Attached are the responses to the piping audit concerns. The attached specification addresses one of the concerns.

NRC Audit of GE on
AEWR PIPING DESIGN CRITERIA AND SAMPLE ANALYSIS
March 23-27, 1992

Figure 3E.2-8 PLOT OF 550°F J_{med} , T_{med} DATA FROM TEST J-R CURVE

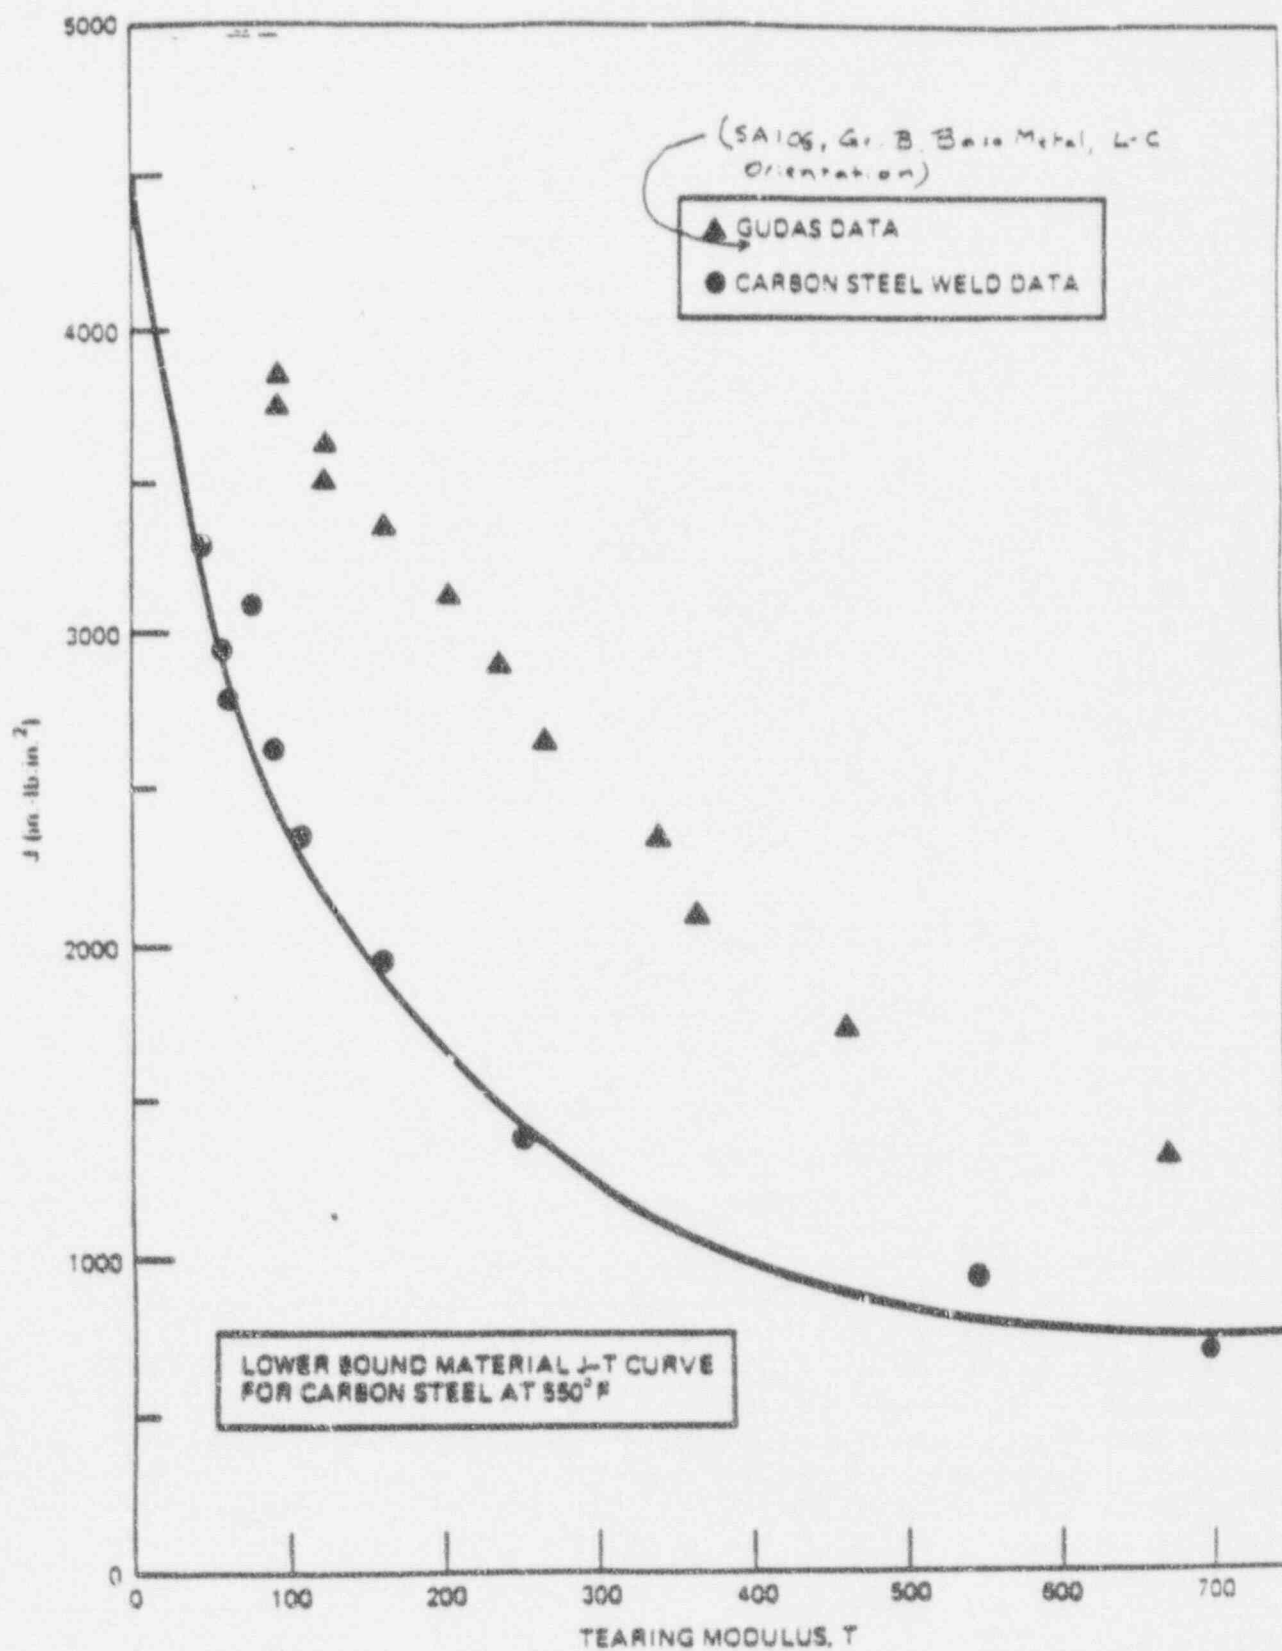
Clarify the Gudas data in Figure 3E.2-8 of the SSAR.

The Gudas data in Figure 3E.2-8 are for carbon steel SA106 Gr. B base metal (with L-C orientation). A clarification is included on the figure.
